Service Bulletin - Integrated Encoder

PRODUCT INVOLVED: GD, GDI and NL120Q/X series.

STARTING FROM S/N: DA00014400

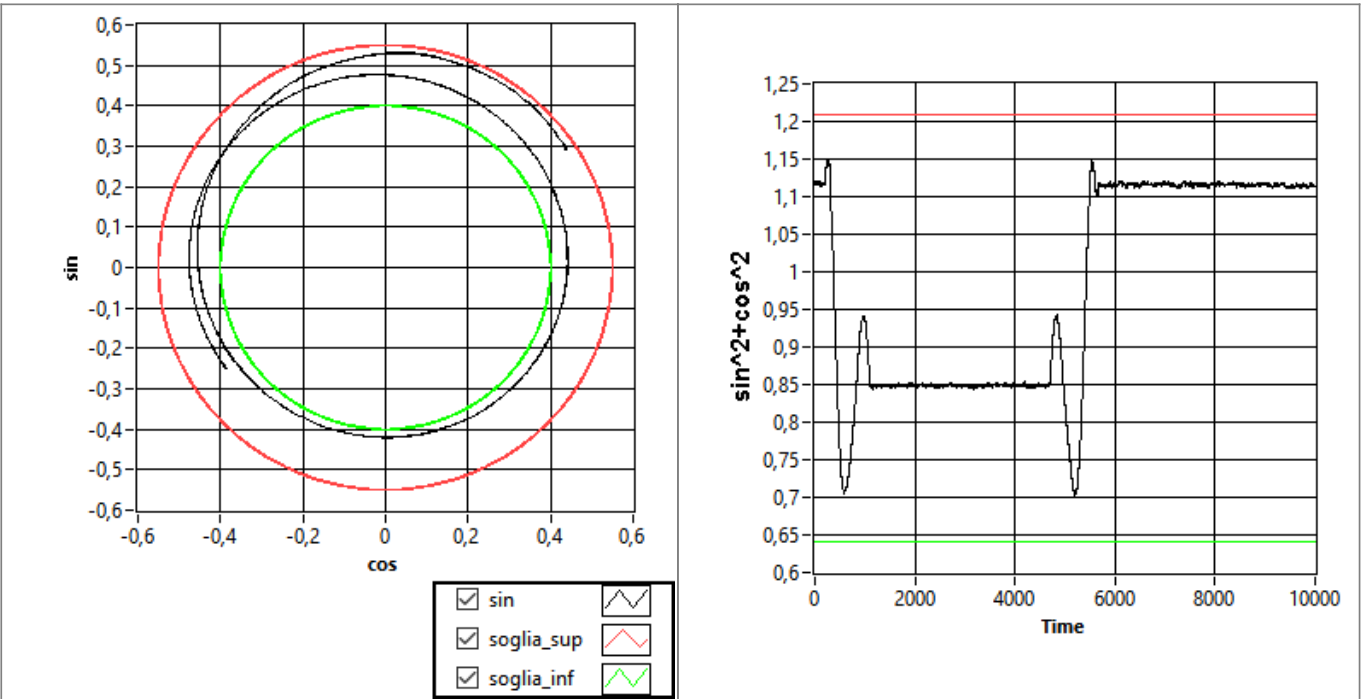
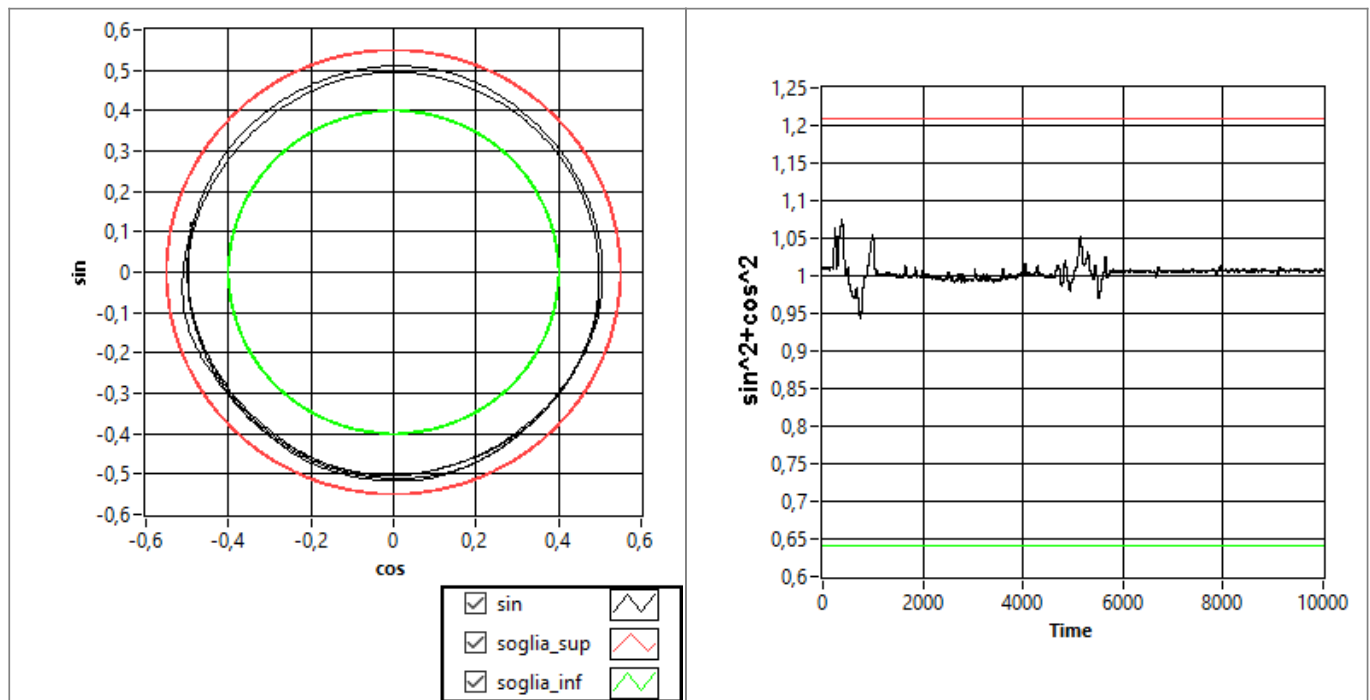
ACTION: Encoder SIN/COS electronics changed: new signal conditioning, filtering and digital calibration.

Item
Protection against wrong voltage application, voltage inversion and output protections.
Better signal quality, offset cancellation, and peak-to-peak variation reduction
Digital Filtering

- 1) New phase angle must be calculated from the servo drive!
- 2) Possible deviation of the tuning parameters on the servo drive
- 3) Possible need to retune the offset and gain if a calibration is present on the servo drive.
